Intel® 82566 Gigabit Platform LAN Connect

Specification Update

January 2012

Figure 2. TP_IDLE Silence Duration and Silence Voltage Template Mask

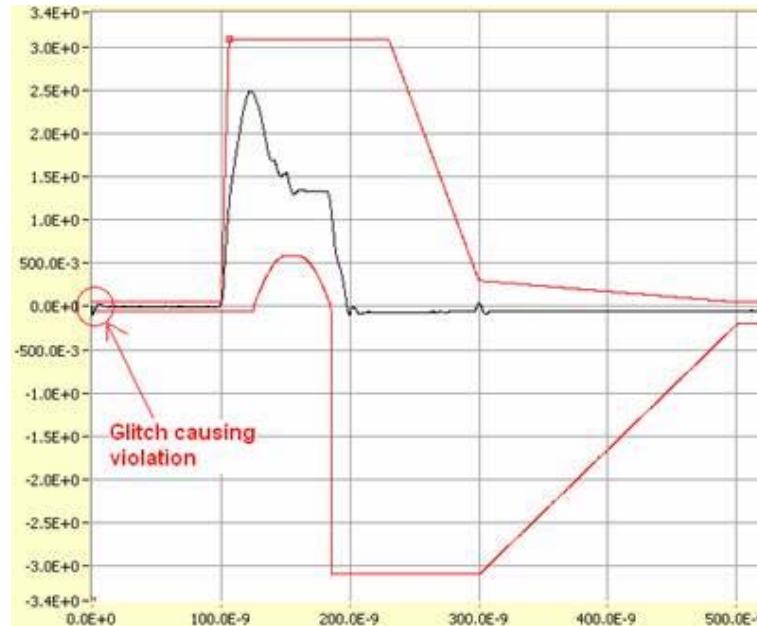
3. 10BASE-T Link Pulse Touches the Template Mask

Problem: The 10BASE-T link pulse waveform touches the template mask due to a small voltage glitch, as measured per the TP_IDLE silence duration and silence voltage test (IEEE 10 Mb test case ID 1411.01.06).

Implication: IEEE conformance is marginal. There is no impact to system level performance. This issue only occurs during 10 Mb Idle Mode. The voltage glitch occurs because the 82566, by default, powers down the transmitter between link pulses (during the 0V output period) to save power. The glitch is visible slightly before the transmission of the link pulse.

Workaround: The workaround prevents transmitter power-down during silence periods. This workaround increases the power consumption of the 82566 ~180mW during 10 Mb idle mode. Customers that desire to implement this workaround should contact their Intel representative for more information.

Figure 3. Typical Scope Measurement of TP Idle with Test Load 2

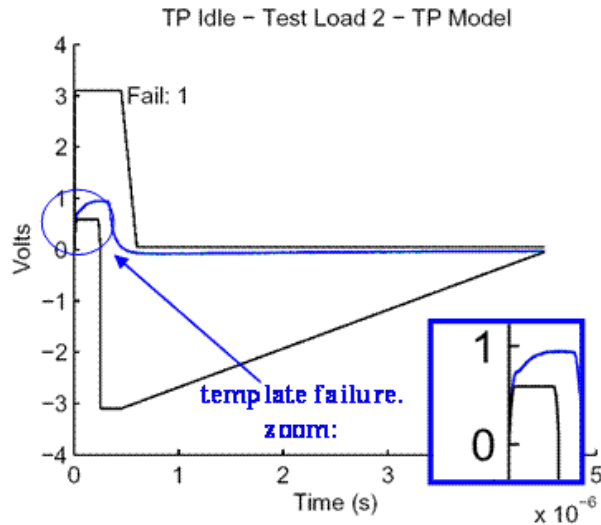
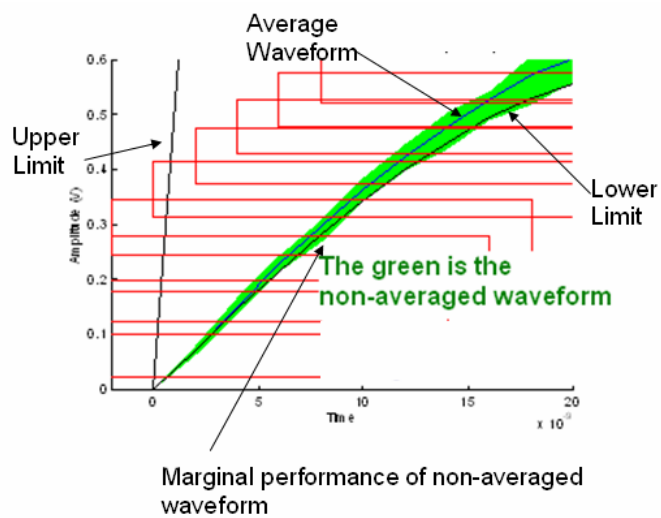
4. 10BASE-T TP_IDL Template Marginality

Problem: The 10BASE-T TP_IDL waveform touches the template mask when tested with twisted-pair model combined with test load 2, per IEEE test case 1411.10.06. There is no issue with the other test loads.

Implication: Per the IEEE specification, the TP_IDL pulse must fit into a template when measured with and without the twisted-pair model for two types of loads (load1 and load2). The combination of the twisted-pair model together with load2 is the challenging one because the waveform is the most attenuated. Some test conditions and methodologies do not apply averaging during the waveform measurement (see non-averaged waveform in Figure 4) and might show marginal IEEE conformance. There is no impact in system level performance.

Workaround: There is currently no workaround.

Figure 5. IVRD Implementation

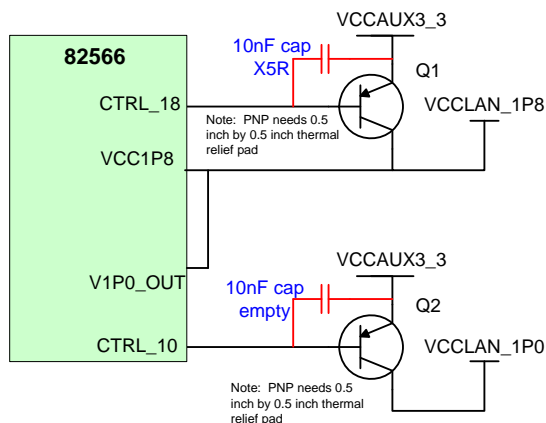
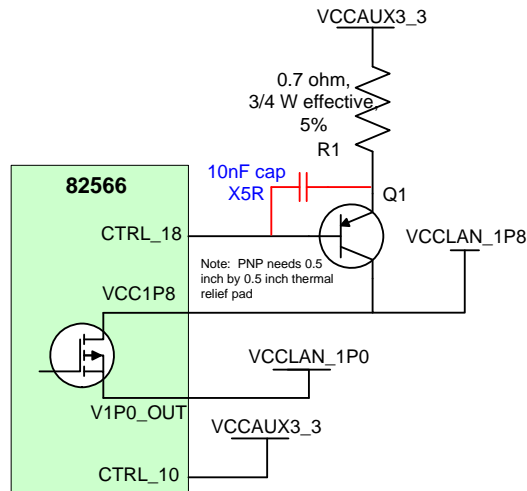
5. Excess Noise on 1.8V Supply

Problem: The 82566 internal LVR controller, when used, creates excessive noise on the LAN 1.8V power supply.

Implication: In some platforms, excess noise has been seen on the LAN 1.8V supply when using the 82566 internal voltage regulator controllers. The issue was observed in both the IVRI and the IVRD modes. The LAN 1.8V noise might feedback into the 3.3V supply as well. This noise could affect the 82566’s ability to meet IEEE specifications.

Workaround: Add a 10 nF cap as shown in Figure 5 and Figure 6. Intel also recommends adding a stuffing option for a 10 nF capacitor (marked do not populate) to the 1.0V linear regulator when in IVRD mode.
